**SUBJECT:** Landing Gear Safety Switch  
(Dukes Pressure Switch Part No. 3203-00)

**MODELS AFFECTED:** All Electric Gear Models

SERVICE LETTER KIT NO. 20-129

**FIGURE 1**  
SERVICE LETTER 20-129

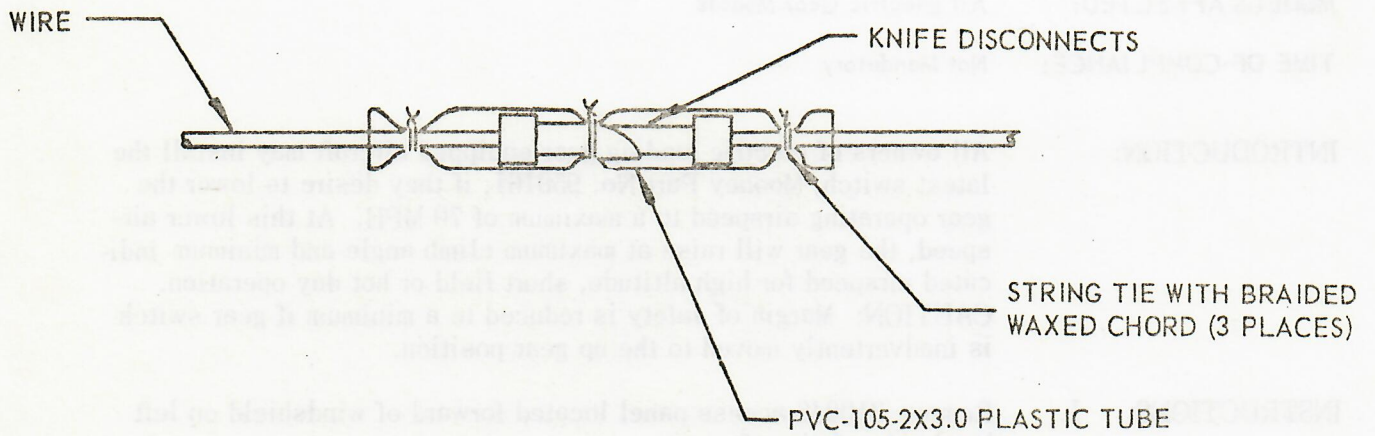
- INSTRUCTIONS:**
1. Remove 310046 access panel located forward of windshield on left hand side of aircraft.
  2. Remove pressure switch by:
    - A. Removing the two AN526-632R4 screws that attach switch to 950130 bracket.
    - B. Cut wires seven inches from switch.
    - C. Unscrew switch from tee in 820020-9 line.
  3. Install new switch by:
    - A. Screwing switch on tee.
    - B. Attach to 950130 bracket with same hardware removed in 2.A.
    - C. Add AMP 32446 knife terminals to the wires in aircraft that were cut from old switch.
    - D. Connect wires and secure as shown on attached drawing.
  4. Replace 310046 access panel.
